# TYPE II DEVELOPMENT & ENVIRONMENTAL REVIEW, STAFF REPORT & DECISION

**Project Name:** 179<sup>th</sup> STREET APARTMENTS

**Case Number:** PSR2009-00040; SEP2009-00081; EVR2009-00043; HAB2009-00072

**Request:** The applicant is requesting site plan approval to construct 115 apartment units in two phases located on 6.99 acres in the R-18 zone.

1 SITE PLAN PHASE II  
A1.1

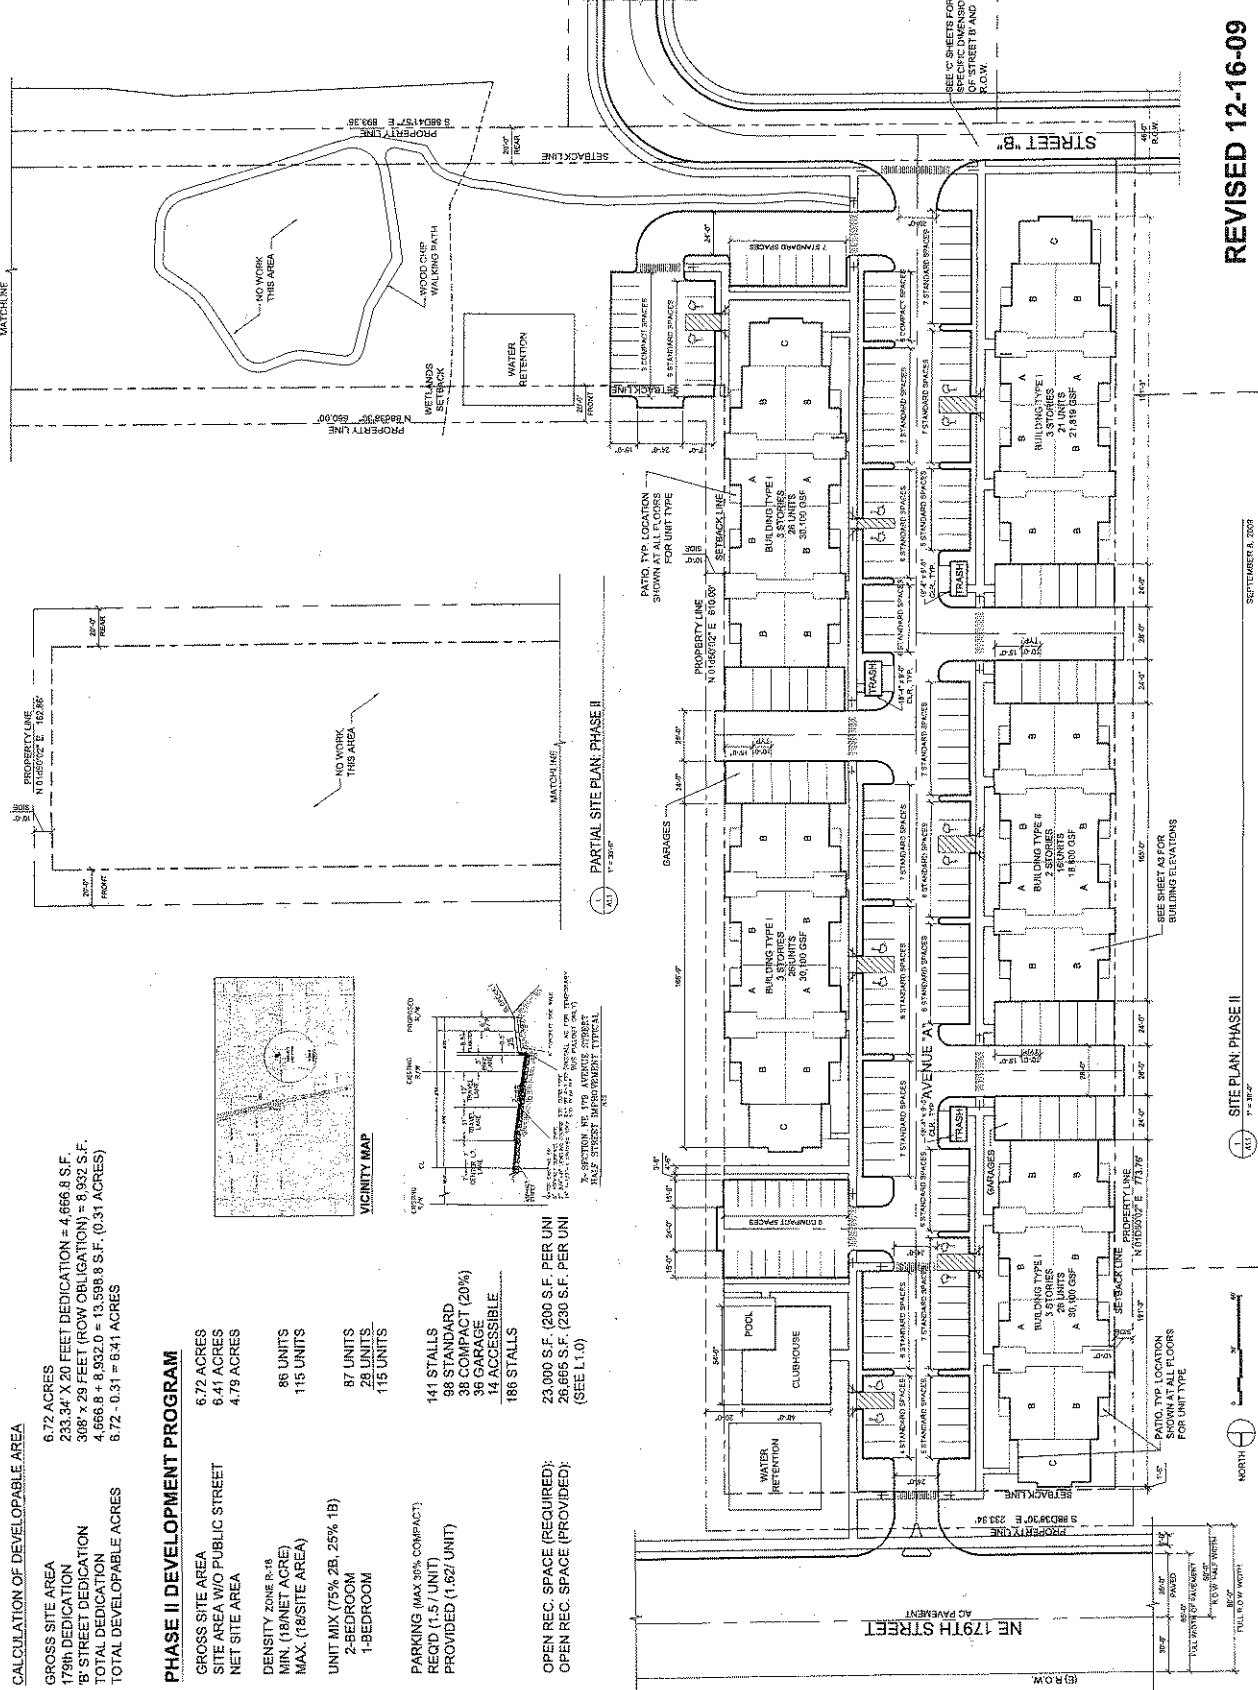
According to the revised site plan (Exhibit 13, sheet A1.1), all structures on the preliminary site plan meet the above setback requirements.

Using the above formulas, the development is required to provide 565 square feet of solid waste storage area for both phases; 520 square feet for phase 1. The trash enclosures shown on the revised site plan (Exhibit 13, sheet A1.1) show 496 square feet however the applicant indicates that each walled in site will be 200 square feet with the recycling added and that would meet the standard. The final site plan will need to be modified to show that this standard is met. (See Condition A-1-e)

The plans show a crosswalk through an ADA access aisle which is not permitted. Either remove or place along side and provide minimum width aisle and crosswalk. (See Condition E-4-i)

- e.** The final site plan shall show a minimum of 520 square feet of solid waste and recycling storage area for phase 1 and 565 square foot for phase 2) (See Land Use Finding 10)

- i. Either remove the crosswalk through the ADA access aisle or place along the side and provide minimum width aisle and crosswalk. (See Building Safety Finding 9)
